Re: FortisBC Energy Inc. (FEI)

**Application for a Certificate of Public Convenience and Necessity for the
Okanagan Capacity Upgrade Project (Application)**

**Response to the B.C. Sustainable Energy Association (BCSEA) Information
Request (IR) No. 1**

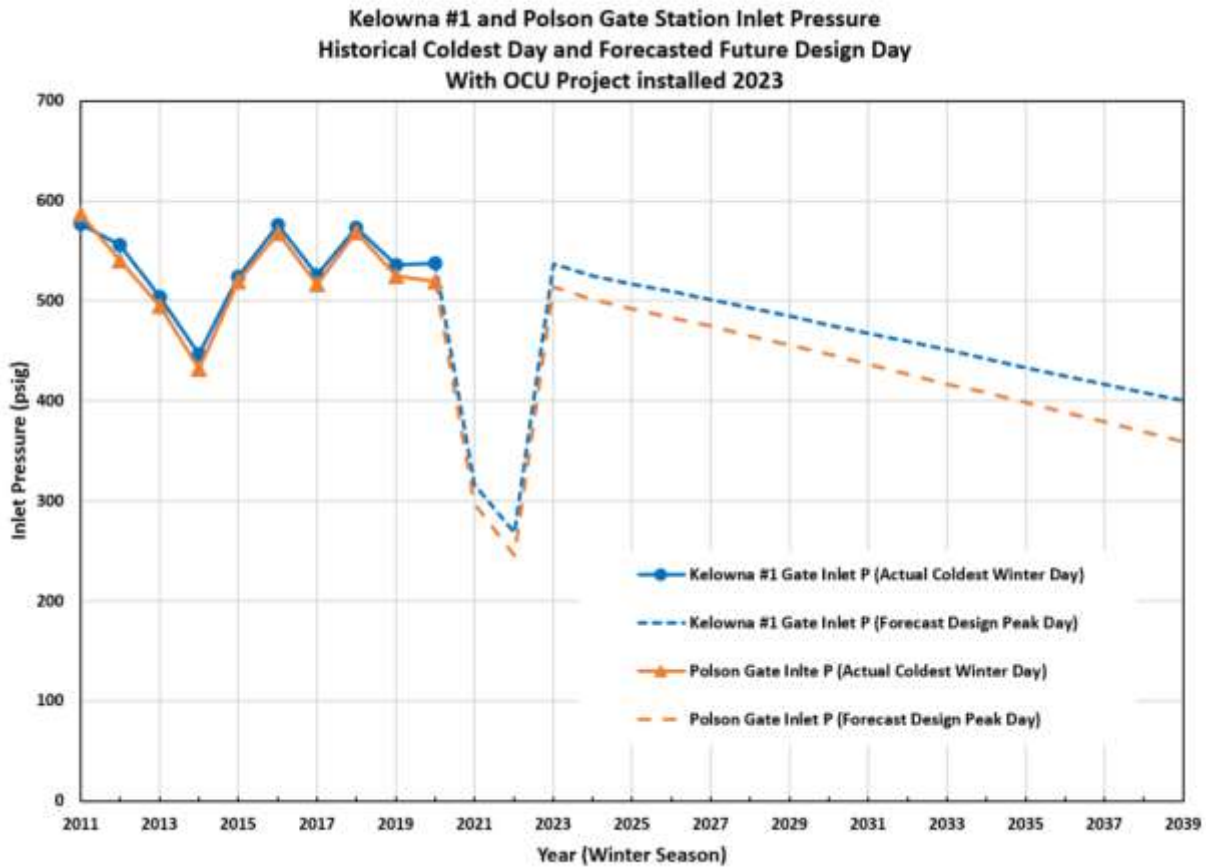
24
25 1.2 Does FEI have data on pressure minima in the north and central Okanagan? If
26 so, please provide a graph and table showing the historical annual minimum
27 pressure in the area of concern, along with the expected future annual minimum
28 pressures in the short term and upon completion of the proposed OLI PEN 406
29 Extension.

32 The following tables and figure provide the requested information for historical actuals on the
33 coldest winter day of the calendar year and forecast expectations for a Design peak day for
34 2021 through 2039 assuming the OCU Project is in service by the winter of 2023-24.

**Minimum Pressure and Peak Demand in the Capacity Shortfall Region
Coldest Winter Day 2011-2020**

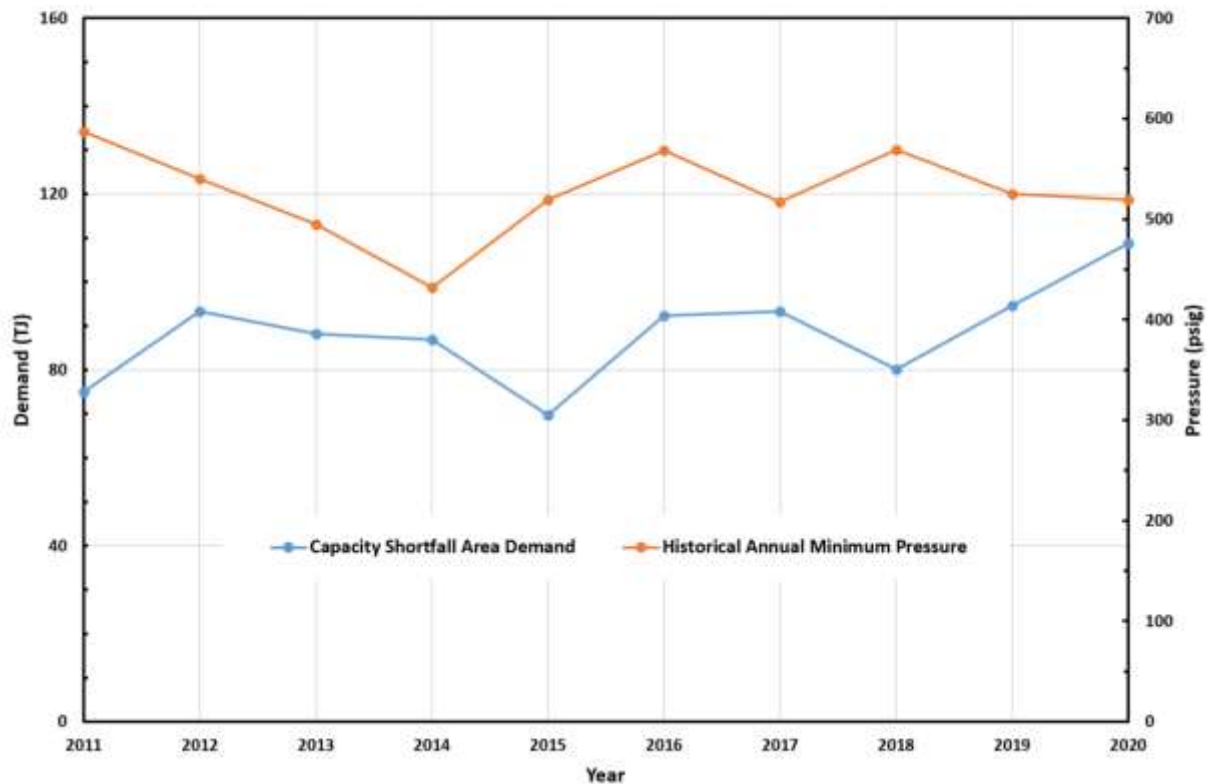
1.3 Please provide a graph and table showing the historical annual minimum pressures in the Capacity Shortfall Area and the annual peak day demand in the area.

2 Please refer to the table and figure for the requested information.

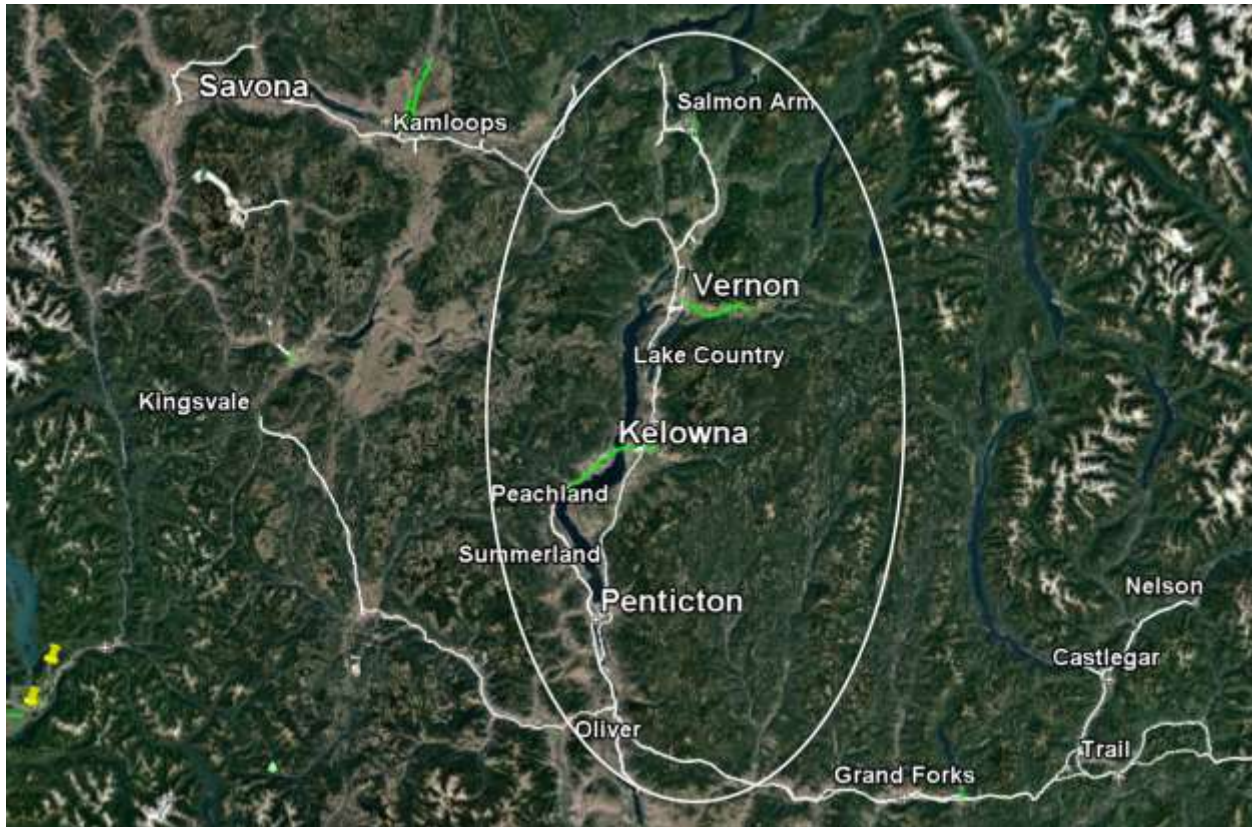
9 2.1 Please provide a version of Figure 3-5 that shows the “Okanagan region” in
10 which 60% of the demand on the ITS is concentrated.

12 The area circled in the figure below shows the Okanagan region in which 60 percent of the
13 demand on the ITS is concentrated.
14

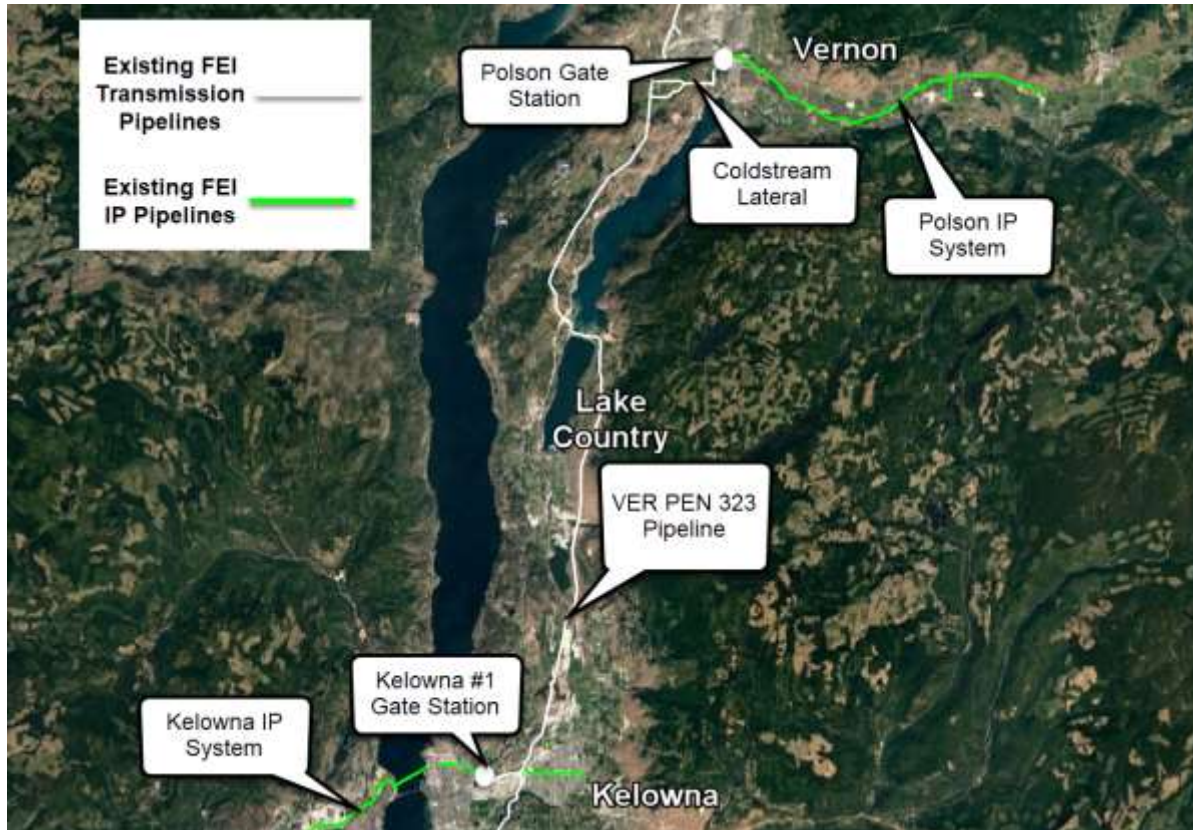
2.2 Please provide a more detailed version of Figure 3-5 that shows the pipelines and pipeline segments within the Capacity Shortfall Region.

The figure below shows additional details of the pipelines and pipeline segments within the circled Capacity Shortfall Region in Figure 3-5 of the Updated Application.

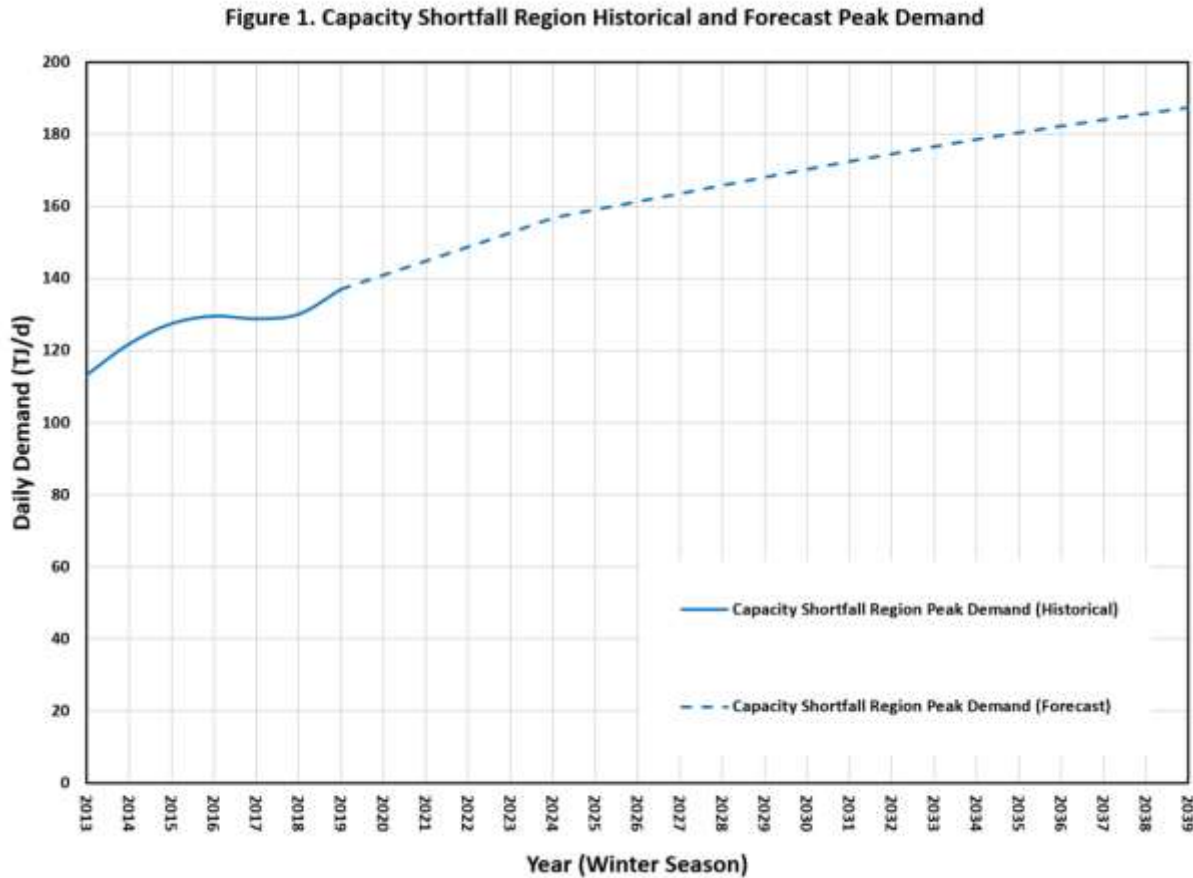
35
36 3.3 Does FEI have historical and forecast peak demand figures for the Capacity
37 Shortfall Region? If so, please provide a graph like Figure 3-6 for the Capacity
38 Shortfall Region.

2 The figure below shows the historical and forecast peak demand for the Capacity Shortfall
3 Region.

Peak Demand Forecast and Capacity in the Updated Application and 2017 LTGRP

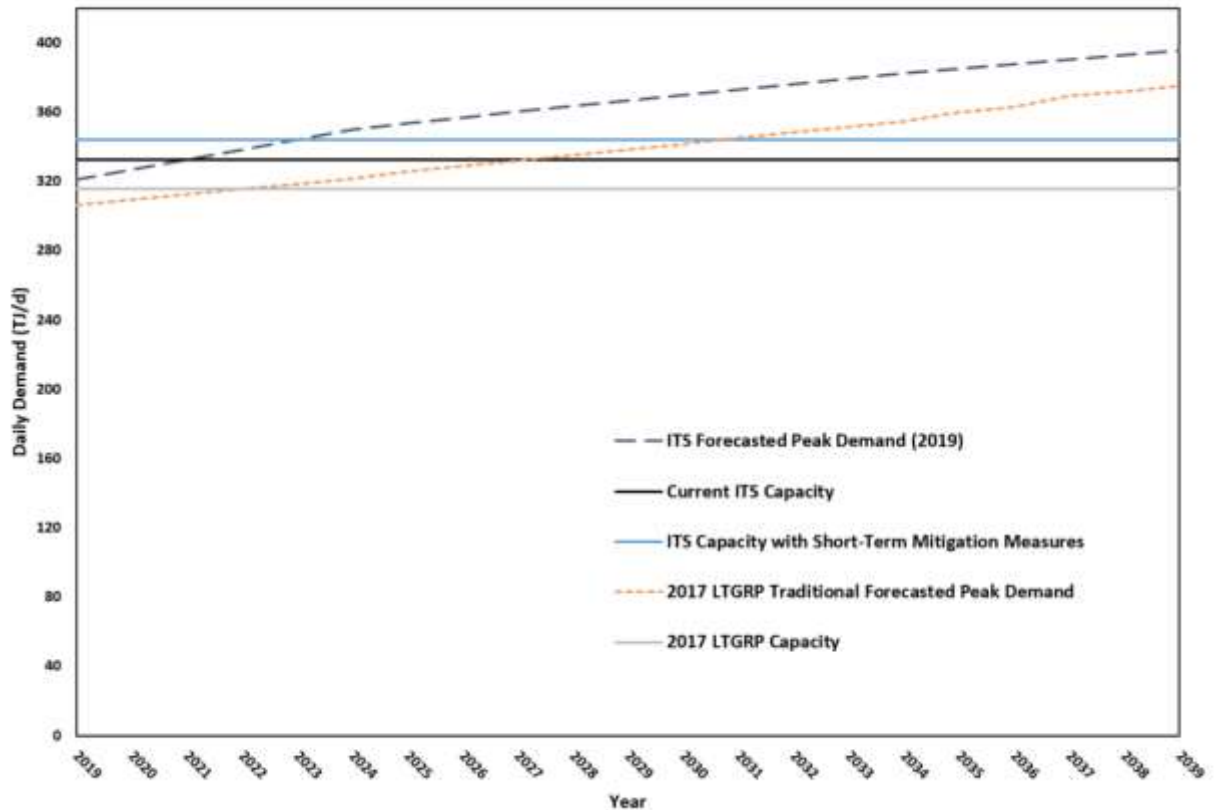
3.8 Please provide a version of Figure 3-6 showing what FEI refers to as “ITS Capacity.” The intention is to show historical changes in ITS Capacity in relation to the historical ITS annual peak demand.

The figure below shows how FEI’s peak demand forecast and capacity on the system has changed between the 2017 LTGRP and the Updated Application. FEI’s forecast peak demand in 2019 was higher than forecast in the 2017 LTGRP. This reflects actual net customer additions in 2016, 2017, and 2018 that were above that 2017 LTGRP forecast. Please see the response to BCUC IR1 4.1.2 for additional discussion of the difference in peak demand forecasts between the 2017 LTGRP and the Updated Application.

With respect to the representation of capacity between the two forecasts, the 2017 LTGRP forecast reflected capacity at the traditional design minimum inlet pressure and is represented as a capacity of 315 TJ per day in the figure against the 2017 LTGRP peak demand forecast.

The “Current ITS Capacity” reflects that the existing Kelowna #1 and Polson Gate Stations had some capacity to accept inlet pressures below the minimum design criteria of 350 psig without requiring mitigation measures. This raises the available capacity reflected in that capacity line. FEI also re-examined the historical maximum Industrial demand and revised it downward in the capacity shortfall region where reasonable to do so. This also has the effect in these plots of raising the capacity line relative to the peak demand curve. The combined effect provided a capacity of 333 TJ per day against the 2019 peak demand forecast.

Then with the mitigation measures, including potential higher delivery pressures from Enbridge at Savona, the temporary ability to achieve the higher capacity is reflected in the higher short-term capacity representation of 344 TJ per day shown in the figure as “ITS Capacity with Short-Term Mitigation Measures”. In addition, please refer to the response to BCUC IR1 10.2 for a breakdown of the capacity impact of the mitigation measures.

1 **Annotated Figure 3-8: ITS Peak Demand vs. Capacity After Completion 1 of OCU Project**

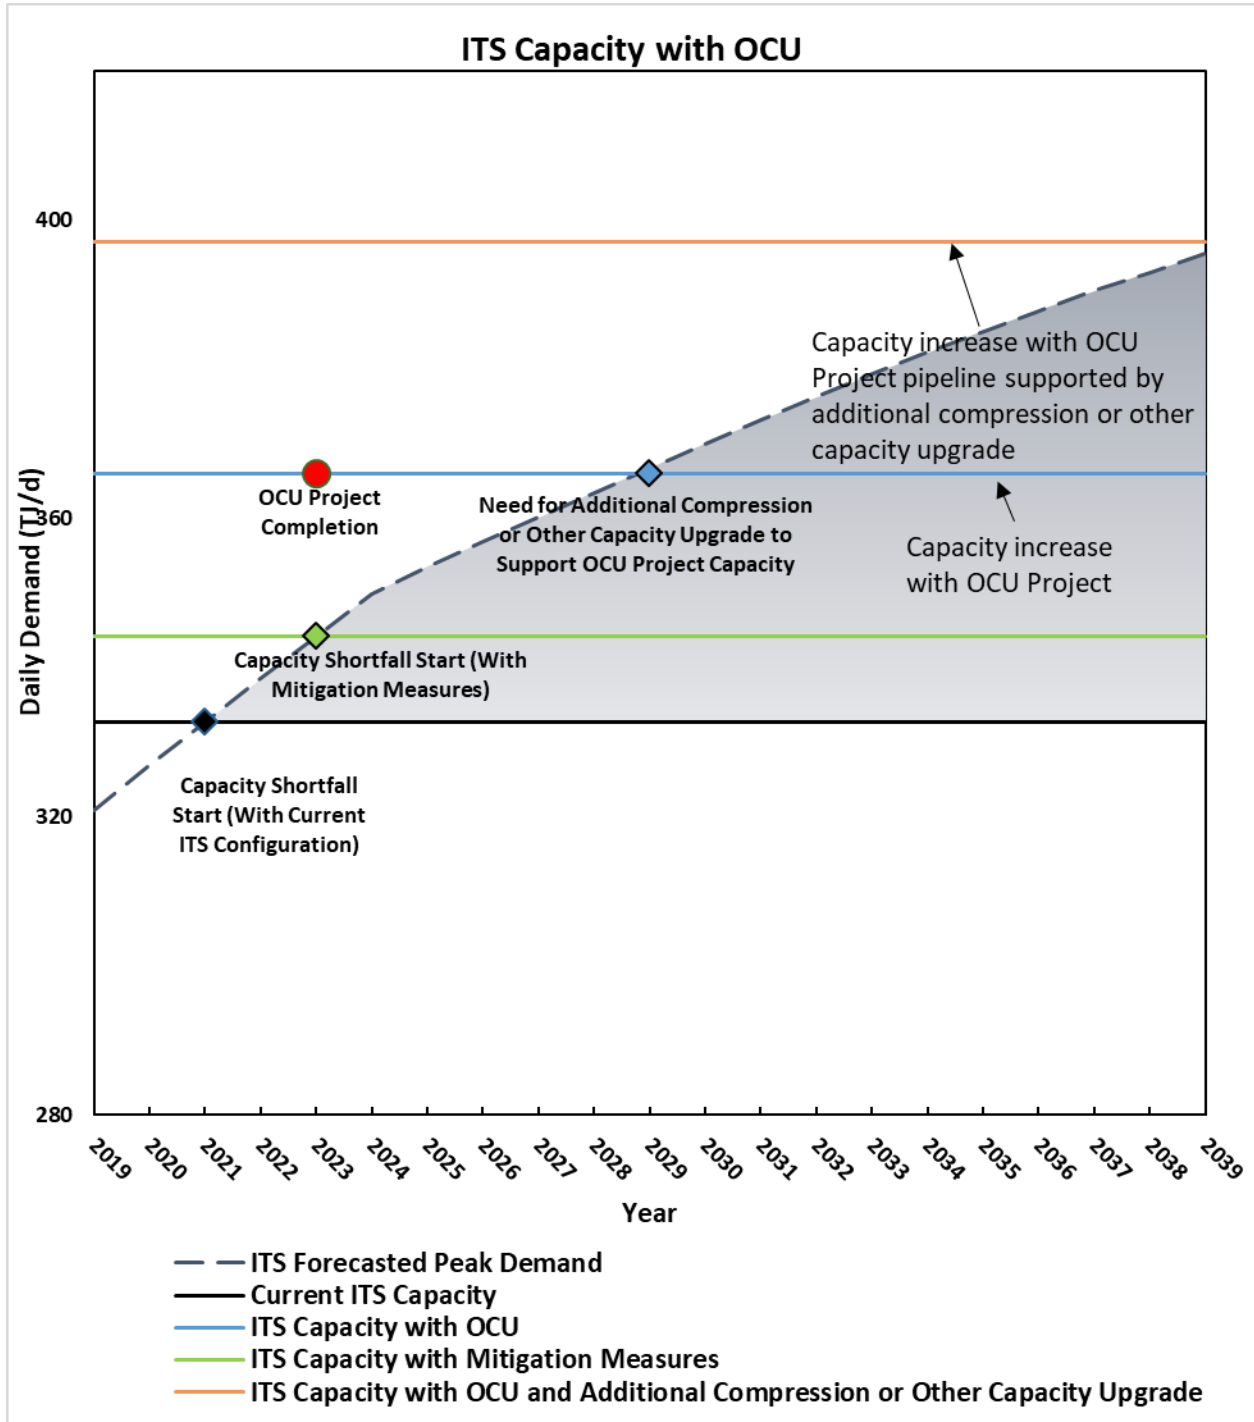
9 4.1 Please provide a version of Figure 3-8 that shows “ITS Capacity with OCU”
10 starting in the appropriate year.

13 FEI has provided an annotated version of the graph below. As shown in the graph, the existing
14 ITS capacity intersects forecast peak demand in 2021 (indicating that a shortfall may occur, as
15 capacity no longer exceeds peak demand). With short-term mitigation measures in place, ITS
16 capacity intersects forecast peak demand in 2023 (indicating that a shortfall may occur, as
17 capacity with mitigation measures would no longer be sufficient to support peak demand). The
18 red point on the graph indicates the planned completion date of the OCU project in 2023. With
19 the OCU Project in place, the ITS capacity is expected to intersect the forecast peak demand in
20 2029 (indicating that a shortfall may occur, potentially requiring added compression to support
21 increasing peak demand). After 2029, additional compression or other gas supply would be
22 needed to provide support for the ITS capacity to meet the 20-year peak demand forecast
